Re: Ti and Addition
2409 Princeton Ave NE
Traffic Circulation Layout
Engineer's/Architect's Stamp 09-20-2019 (H16D125)

Based upon the information provided in your submittal received 09-25-2019, the above referenced plan cannot be approved for Building Permit until the following comments are addressed:

A FACADE RENOVATION, BLDG. ADDITION & TENANT IMPROVEMENT
2409 PRINCETON AVE. NE ALBUQUERQUE, NEW MEXICO

TCL

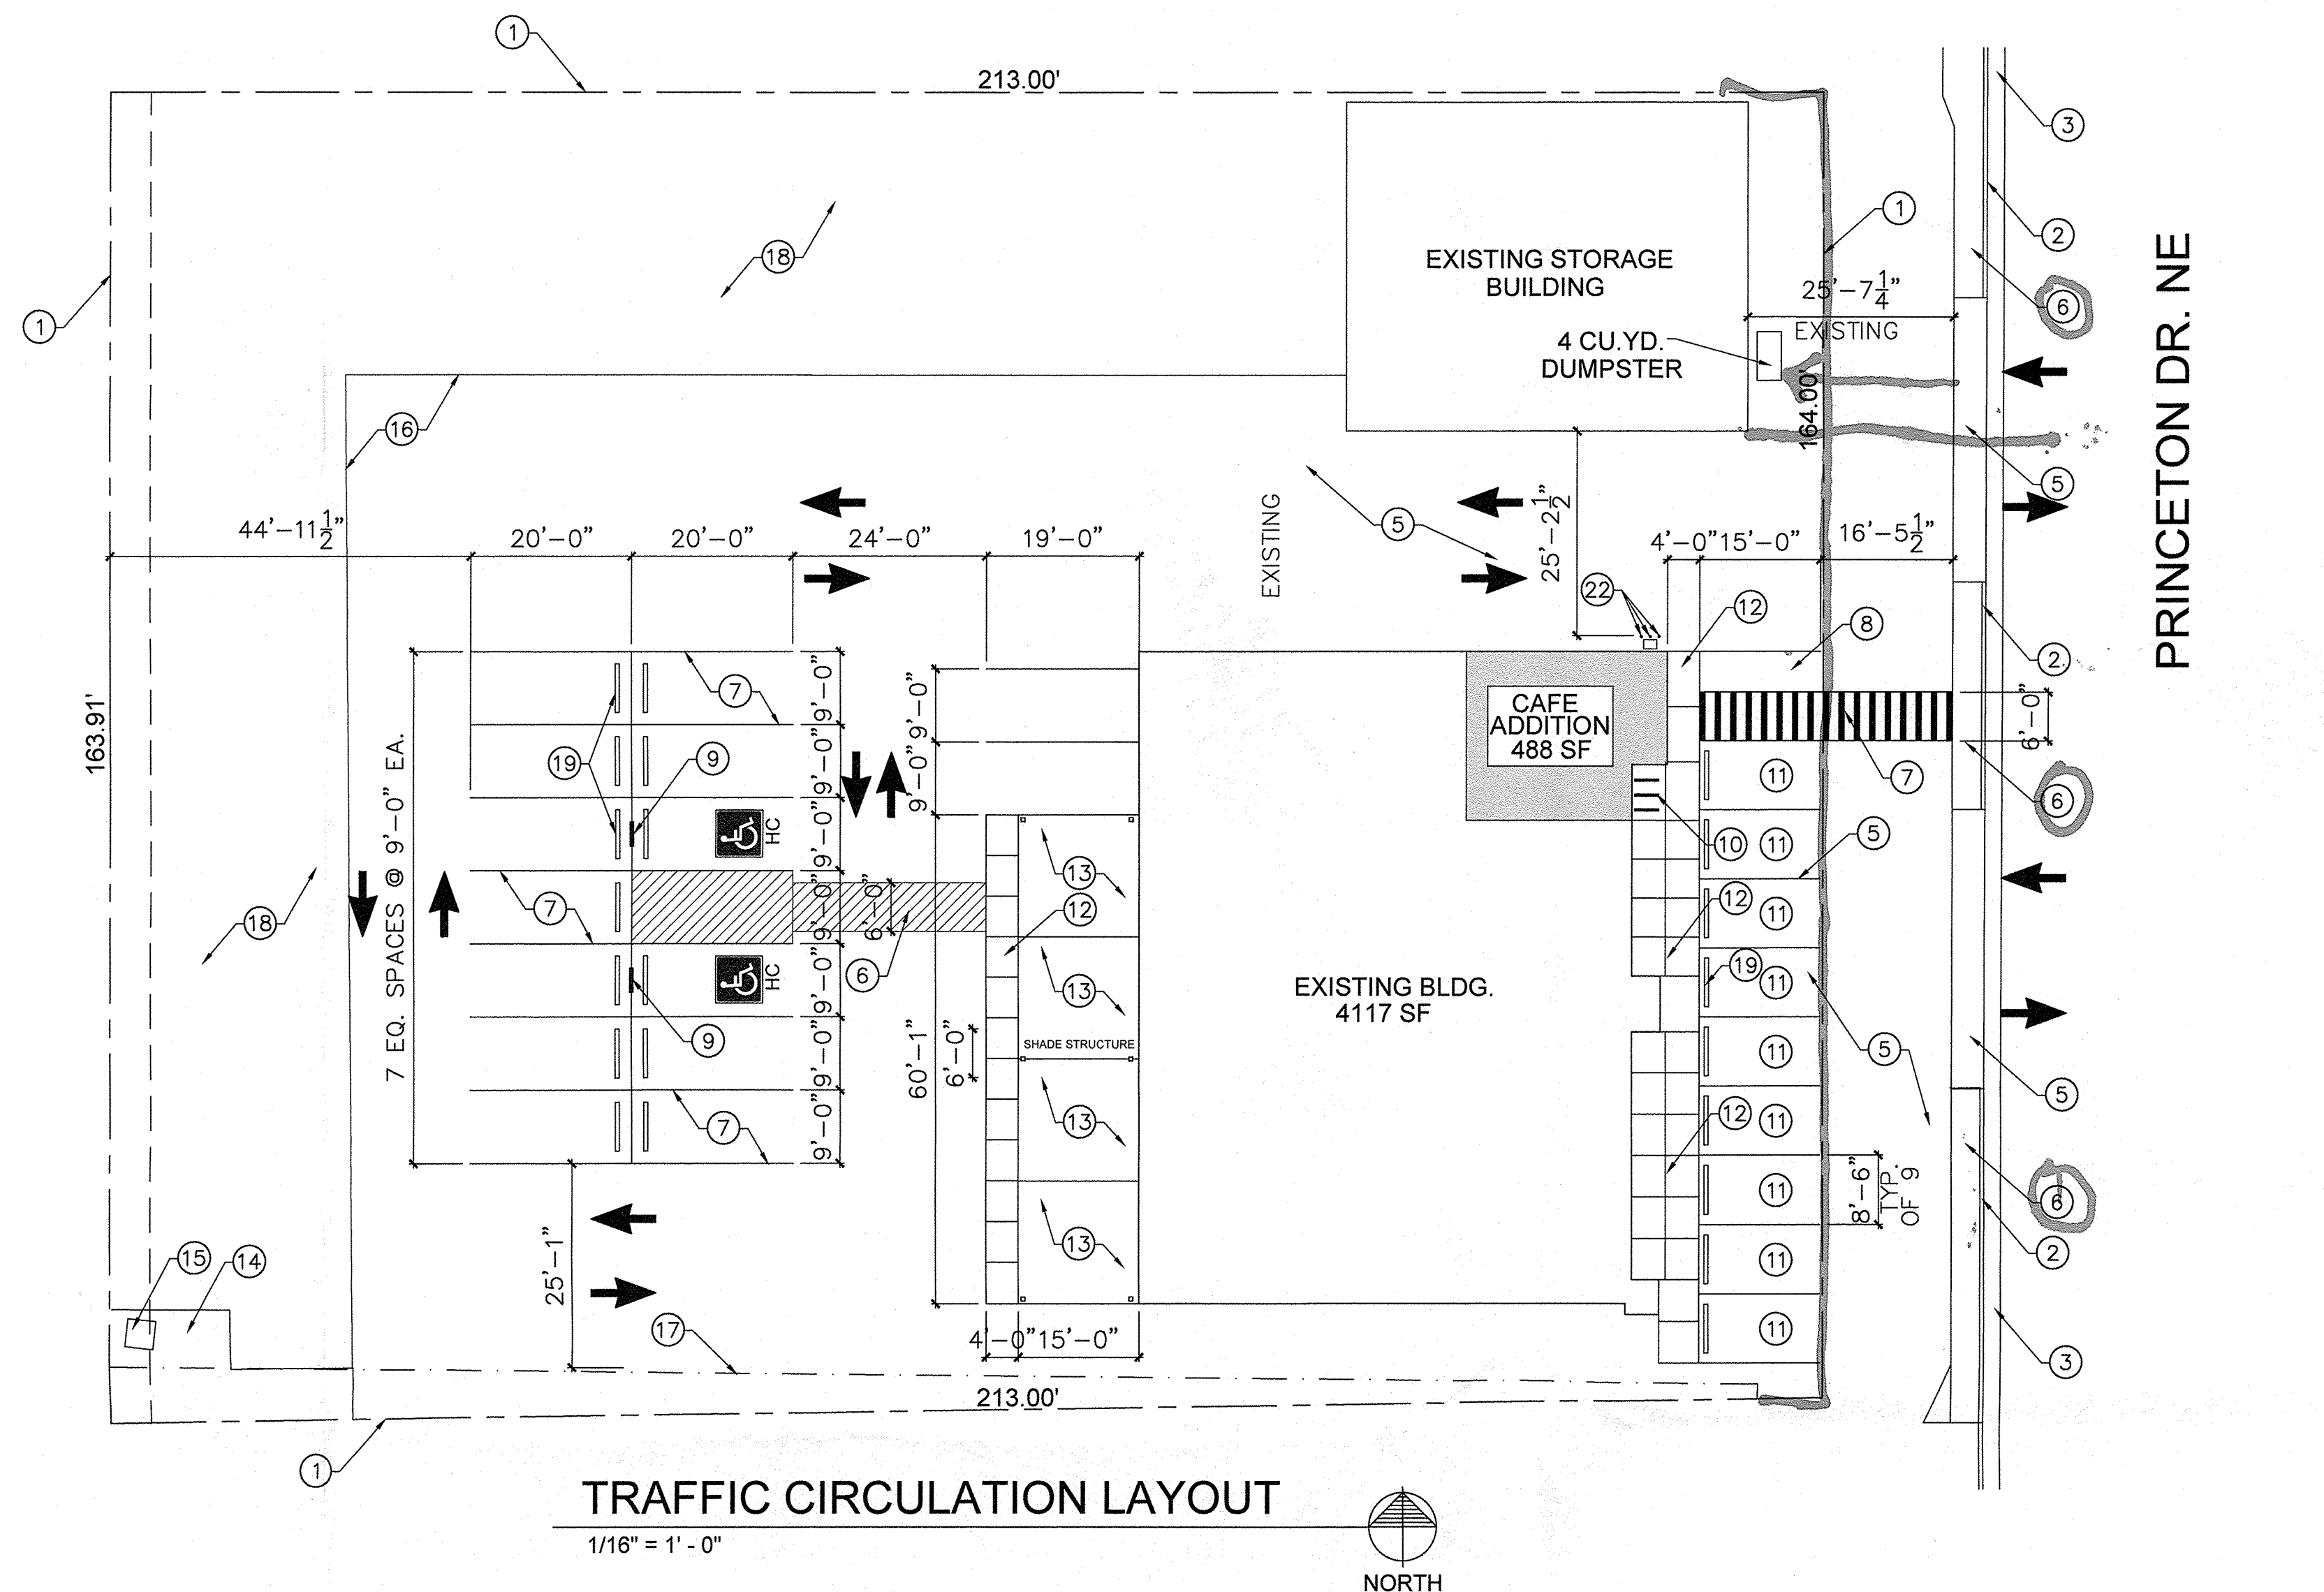
1. The site access through Princeton Dr. should be moved to the south because there is a storage building in front of it.
2. Label the compact parking spaces by placing the words "**COMPACT**" on the pavement of each space.

3. The ADA access aisles shall have the words "**NO PARKING**" in capital letters, each of which shall be at least one foot high and at least two inches wide, placed at the rear of the parking space so as to be close to where an adjacent vehicle's rear tire would be placed. (66-1-4.1.B NMSA 1978)

4. Motorcycle parking spaces shall be designated by its own conspicuously posted upright sign, either free-standing or wall mounted per the zoning code.

5. All bicycle racks shall be designed according to the following guidelines:
 - a. The rack shall be a minimum 30 inches tall and 18 inches wide.
 - b. The bicycle frame shall be supported horizontally at two or more places. Comb/toaster racks are not allowed.

- c. The rack shall be designed to support the bicycle in an upright position. See the IDO for additional information.
 - d. The rack allows varying bicycle frame sizes and styles to be attached.

- e. The user is not required to lift the bicycle onto the bicycle rack.
 - f. Each bicycle parking space is accessible without moving another bicycle.

6. Bicycle racks shall be sturdy and anchored to a concrete pad.
7. A 1-foot clear zone around the bicycle parking stall shall be provided.

8. Bicycle parking spaces shall be at least 6 feet long and 2 feet wide.
9. Per DPM, a 6 ft. wide ADA accessible pedestrian pathway is required from the ADA parking stall access aisles to the building entrances. Please clearly show this pathway and provide details.
10. You will need a revocable permit to access the parking spaces in front of the building. The other option would be to move those parking spaces to a different location if you don't want to get a revocable permit.
11. And the keyed note needs some attention. For example there are two 7's, numbers 20 and 21 is not shown on the plan, and number 6 is pointing to two different things.
